**COMMENTS TO CERTAIN STATEMENTS/FINDINGS OF THE ‘DOCUMENTATION ON THE LIKELY SIGNIFICANT TRANSBOUNDARY IMPACT OF THE UKRAINIAN DEEP-WATER NAVIGATION CANAL DANUBE-BLACK SEA IN THE CONTEXT OF ESPOO CONVENTION, 1991’ (February 2005)**

**Comments to Part II**

**Figure:** Mean annual flow distribution in the Ochakiv System of Chilia Delta (in % to the total Danube flow), and flow projections till 2015. Ochakiv System branches: 1 – Ochakivsky (head); 2 – Belgorodsky; 3 – Ankudinov; 4 – Poludenny; 5 – Prorva; 6 – Potapovsky; 7 – Gneushev; 8 – Link Canal

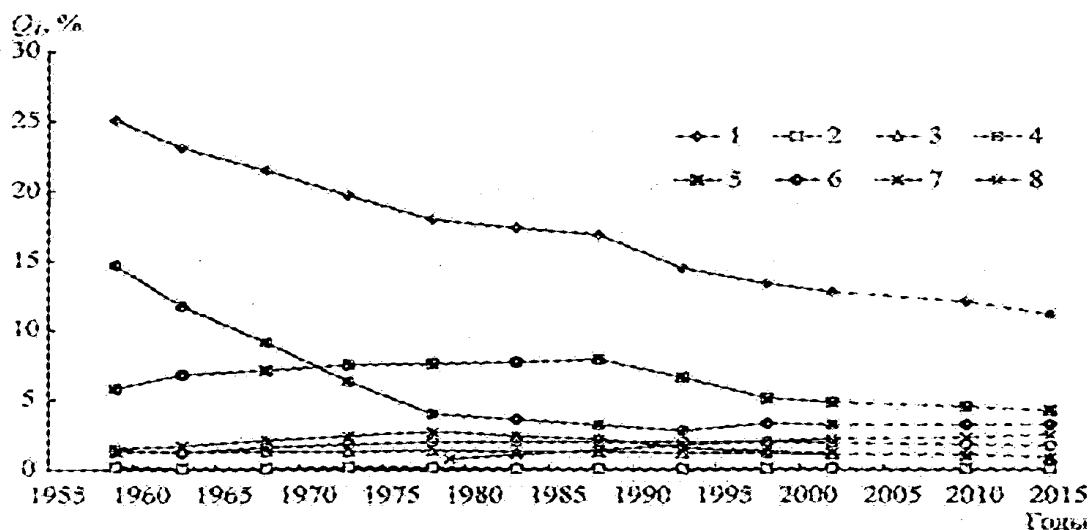
*Water abundance in the Ochakiv Branch* has decreased by 2-fold over the past 45 years, and this trend is expected to continue in the future (Figure), being attributed to both natural factors (the progressive disappearance of the lower section of the Ochakiv Branch system and decrease in water abundance in the Kilia Branch) and technogenic factors (hydraulic engineering activities in the Romanian part of the Danube Delta).

**Dredging activities, constituting an essential element of the DNWR reopening, would produce only a minor impact on this process** as the expected redistribution of the Danube flow, leading to a 1% increase in water flow carried through the Bystre Branch, will be caused by a respective increase in water abundance in the Chilia Arm, and will not affect the flow discharge rates in the Ochakiv Branch. It can be therefore concluded that **the current and expected degradation of plant communities in the northern part of the Danube Biosphere Reserve is not associated with the DNWR reopening. However, (part of) compensation payments envisaged under the project can be used to finance the measures on restoring wetland communities in this area of the reserve.**
